Re: Proposed Commercial Development
Blue Hill Avenue/Temple Shalom of Milton
Milton, Massachusetts

Vanasse & Associates, Inc. (VAI) is providing detailed responses to the comments raised in the January 29, 2010 memorandum prepared by Howard/Stein-Hudson Associates, Inc. (HSH) on behalf of the Town with respect to their review of the December 17, 2009 Traffic Impact Assessment (the “December 2009 TIA”) prepared by VAI in support of the proposed neighborhood retail plaza to be located off Blue Hill Avenue (Route 138) and on the site of the Temple Shalom of Milton in Milton, Massachusetts (the “Project”). Listed below are each of the comments raised in HSH’s subject memorandum followed by our detailed response.

SIGHT DISTANCE FIELD MEASUREMENTS

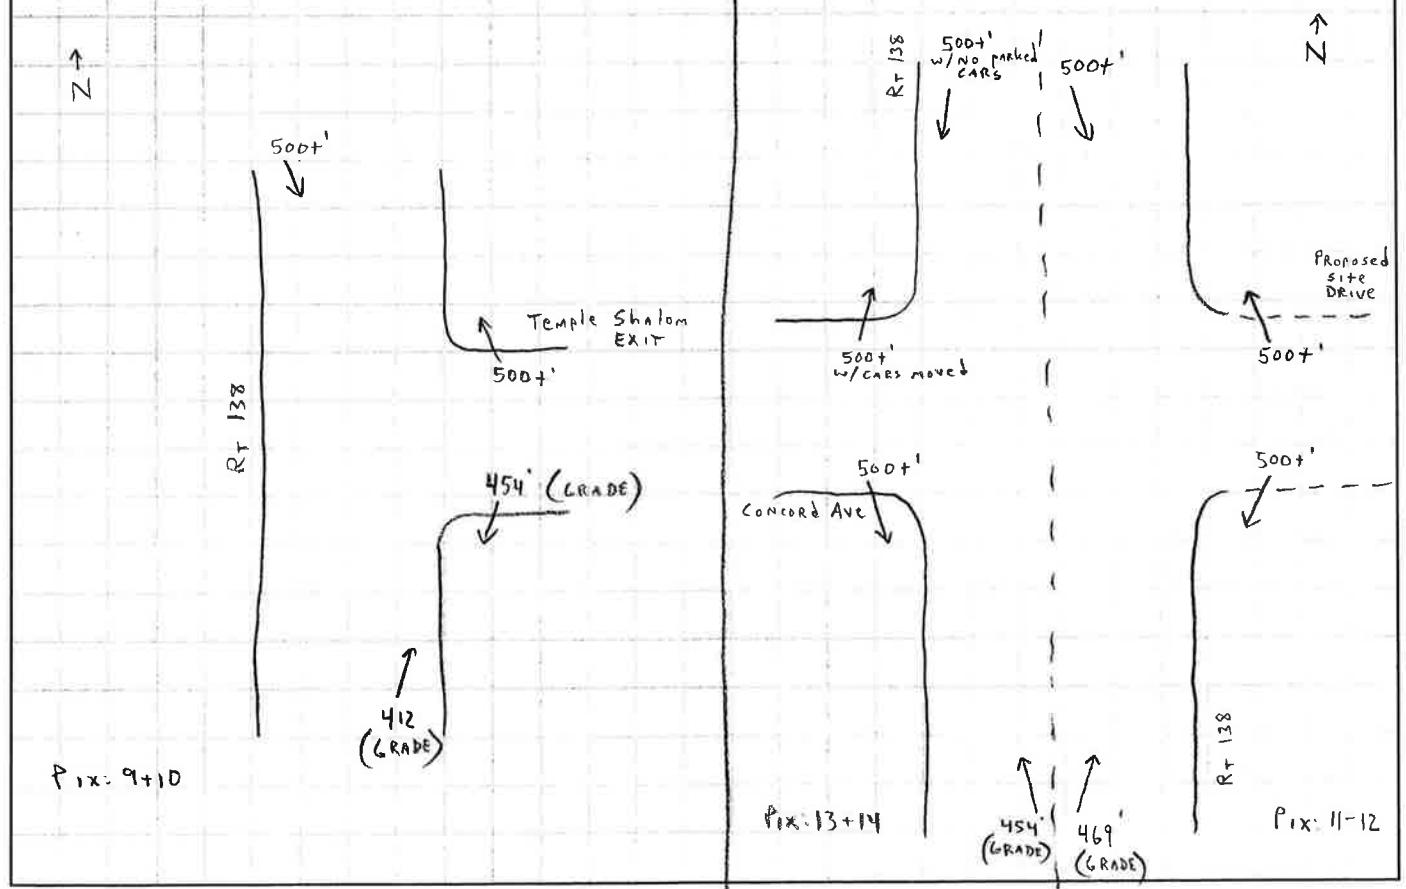
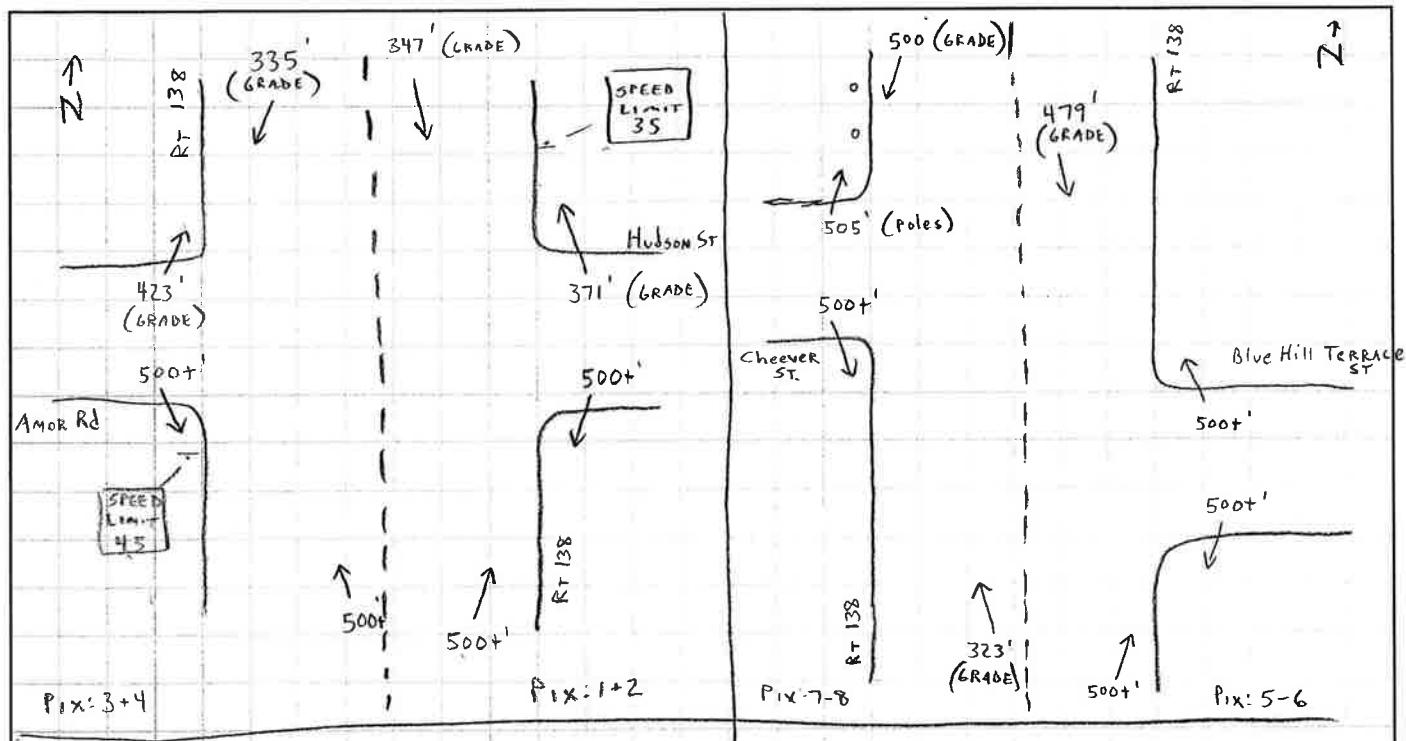
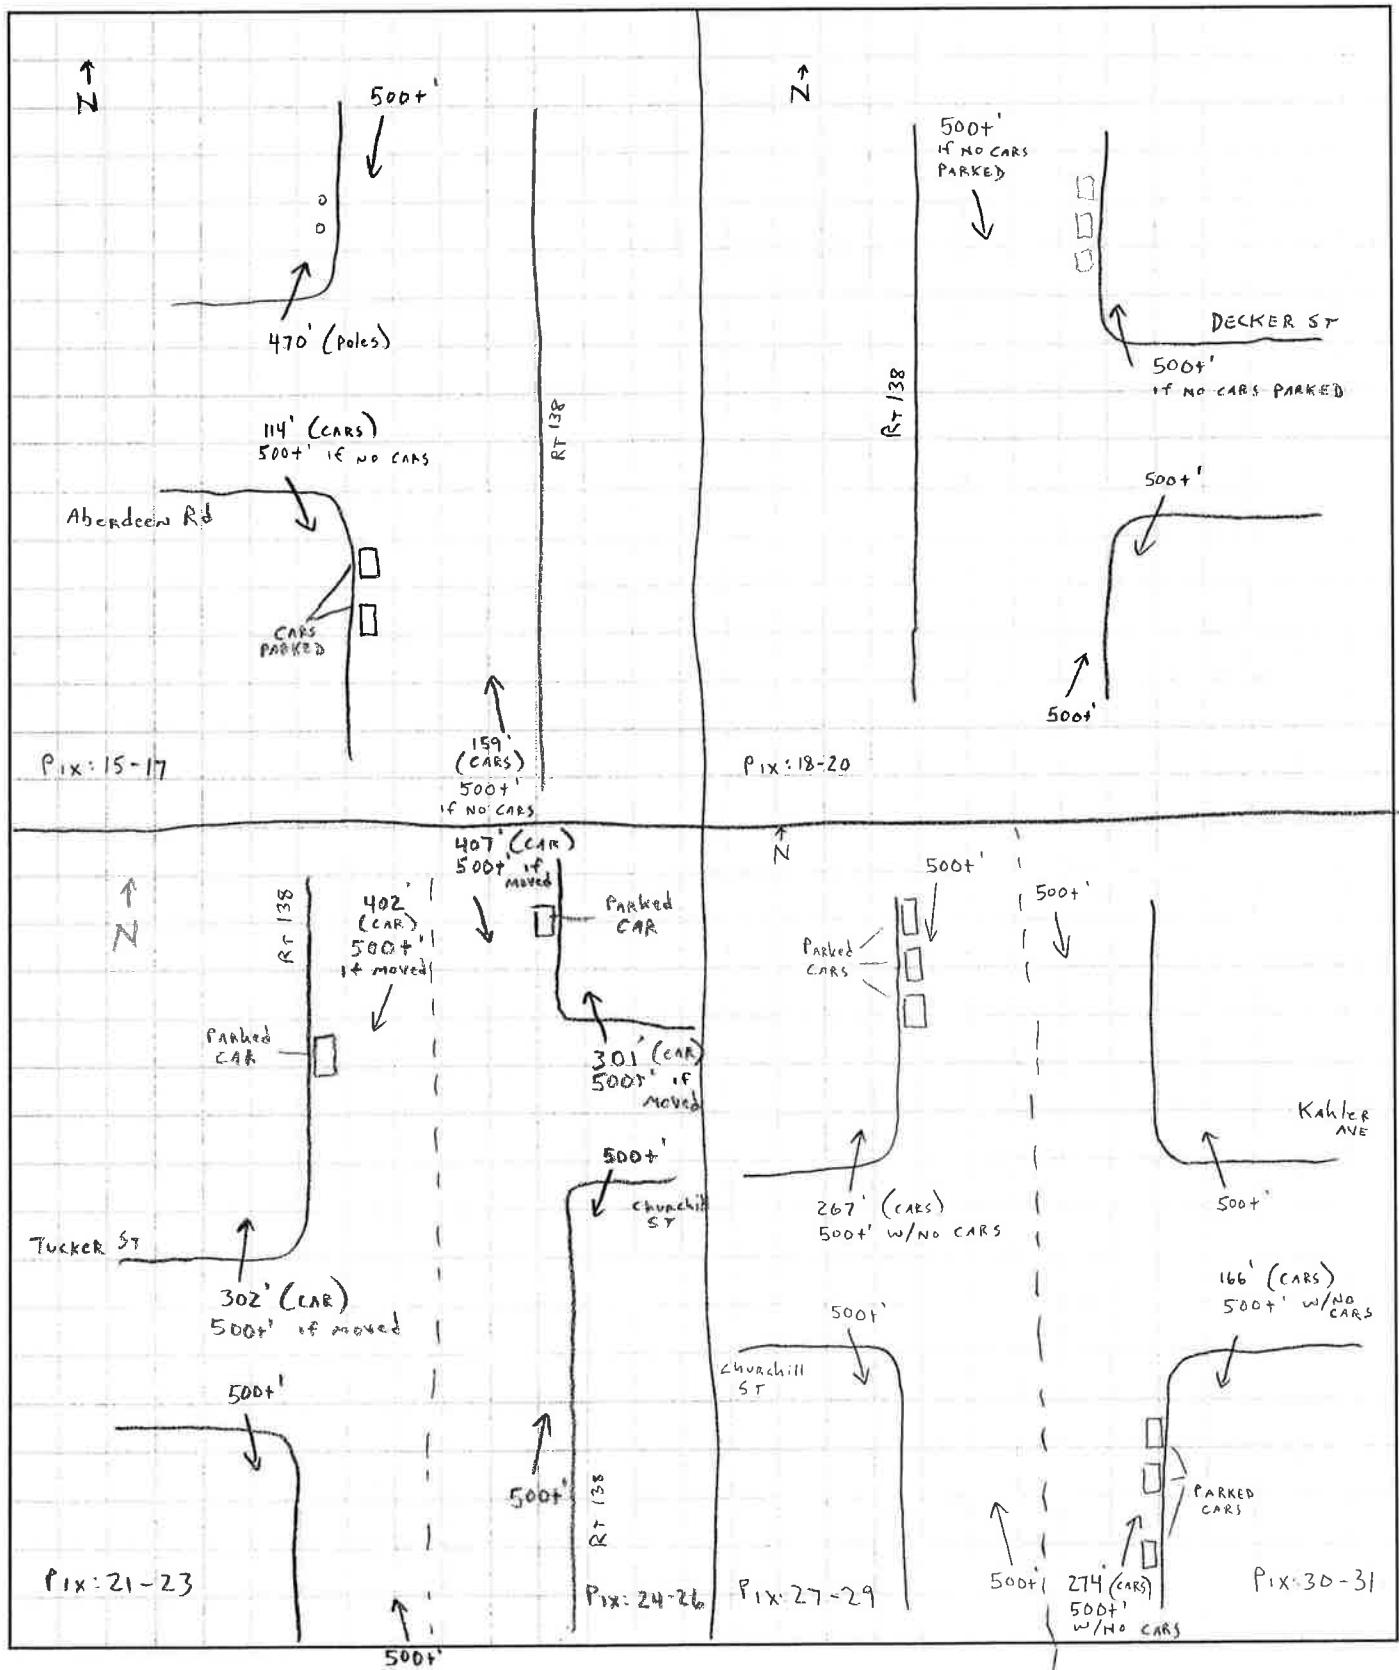
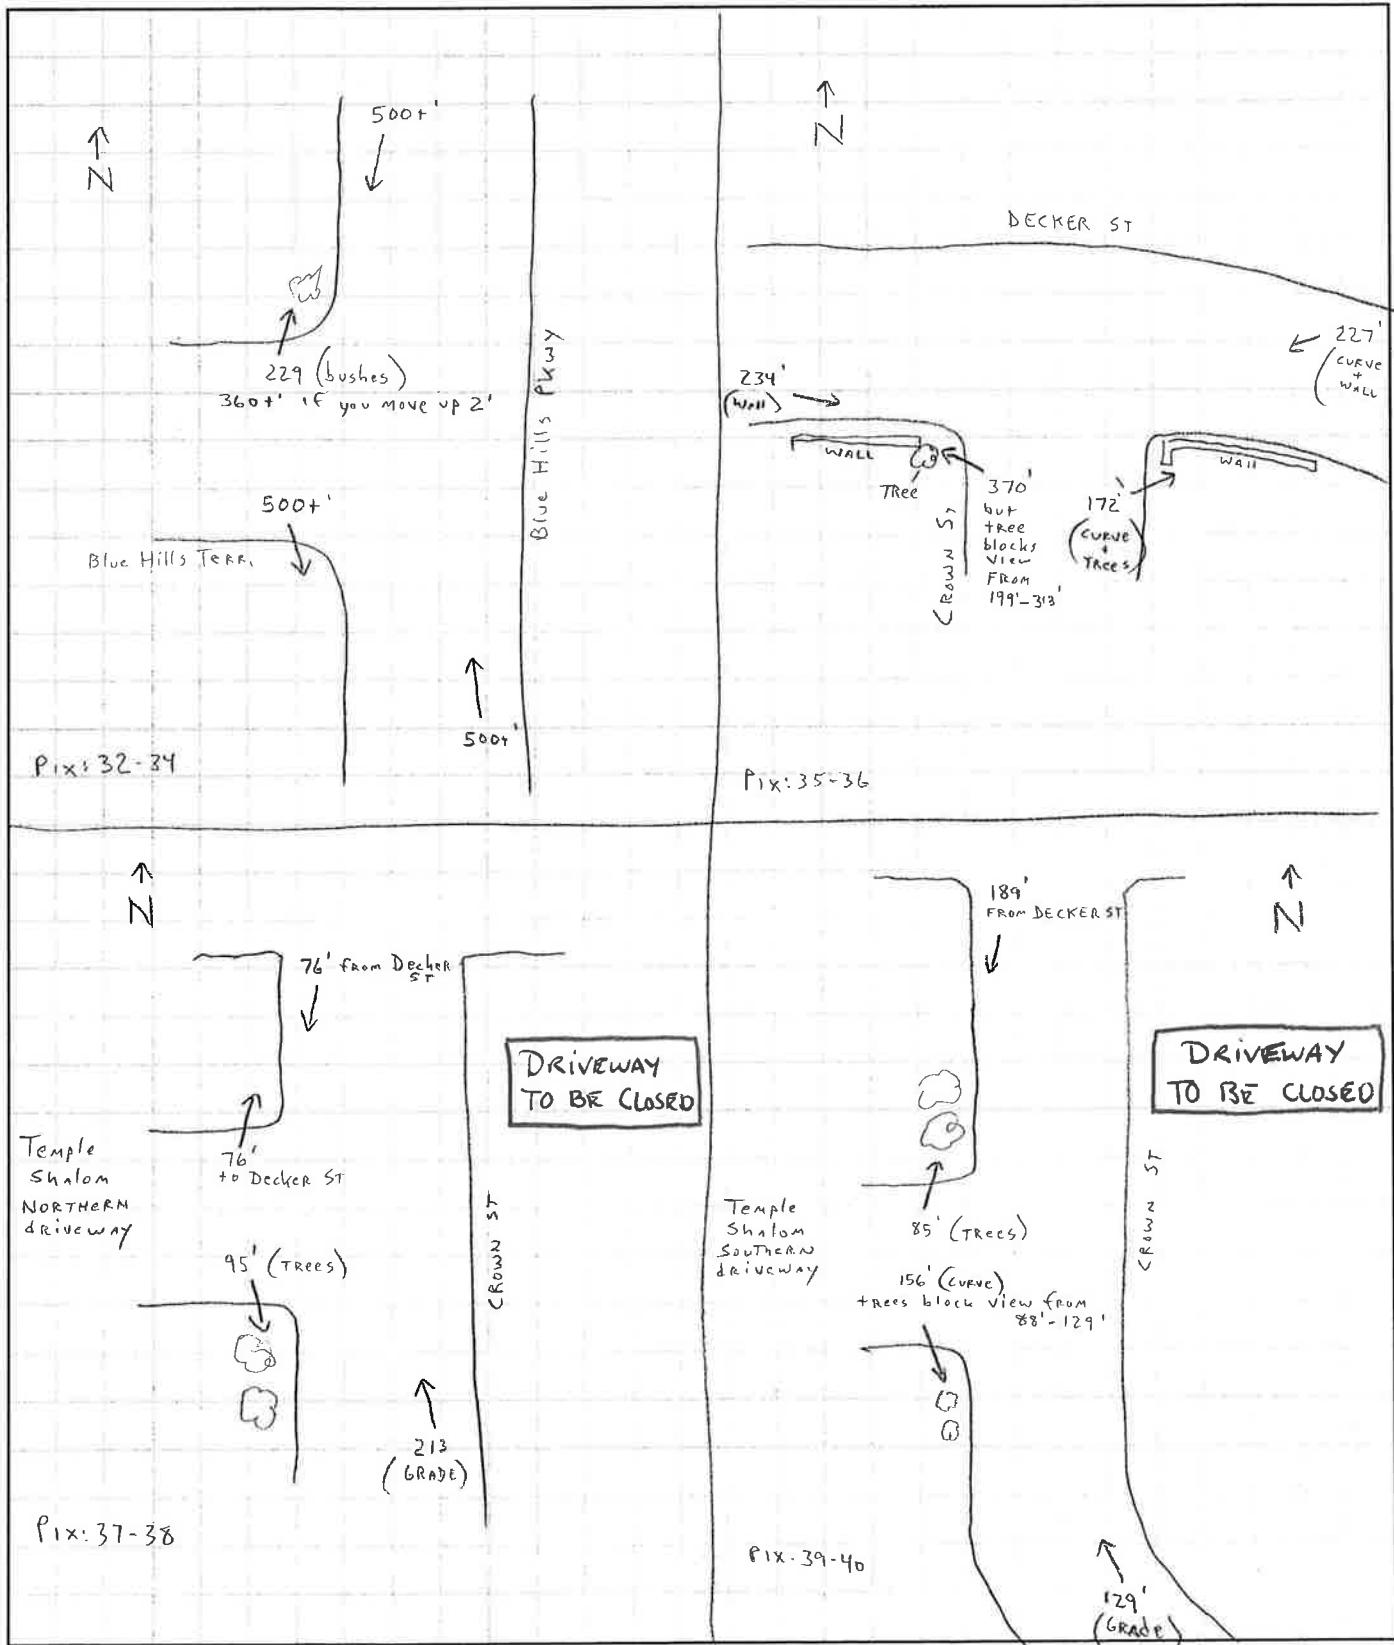
Comment: *"The proponent should review the remaining study area intersections to identify other locations where sight distance may be a concern."*

Response: Sight distance measurements were completed at all of the study intersections as requested by HSH. Copies of the requisite field notes are included in the appendix attached hereto. Based on a review of these measurements, all of the study intersections were found to meet or exceed the required sight distances for the posted, statutory and/or measured travel speed along the intersecting roadway with the following notation:

When present, vehicles parked on-street and proximate to an intersection (within 25 feet) were found to limit sight lines from the minor street approach. It is suggested that on-street parking, where permitted, be prohibited within 25-feet of an intersection in order to provide and maintain the required sight lines.

**Institute of Transportation Engineers (ITE)
Trip Generation, 8th Edition
Land Use Code (LUC) 850 - Supermarket**

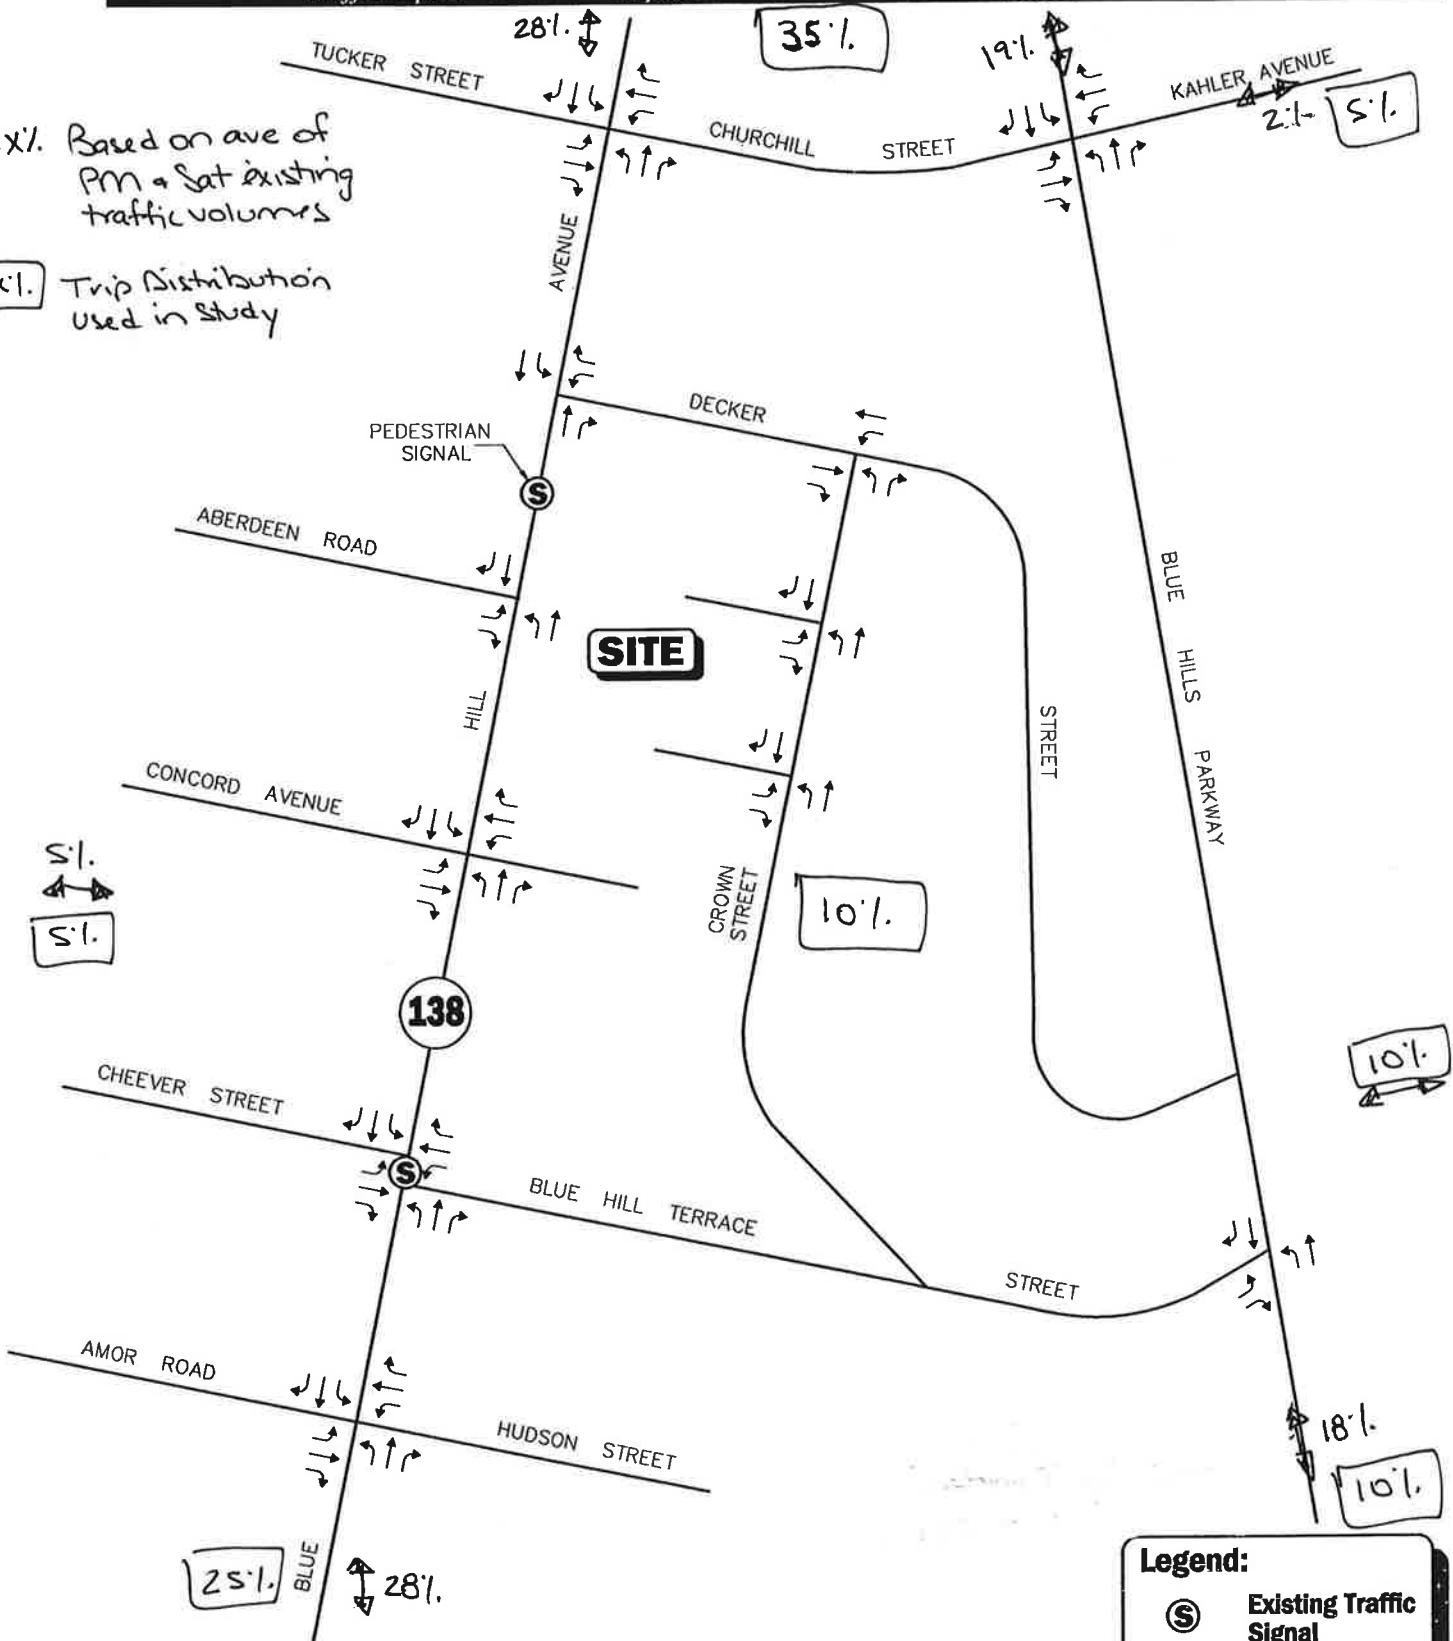
Comment: *"The proponent should provide detailed trip generation calculations in the appendix for LUC 850 (Supermarket)."*

Response: The requested trip-generation worksheet is included in the appendix attached hereto.
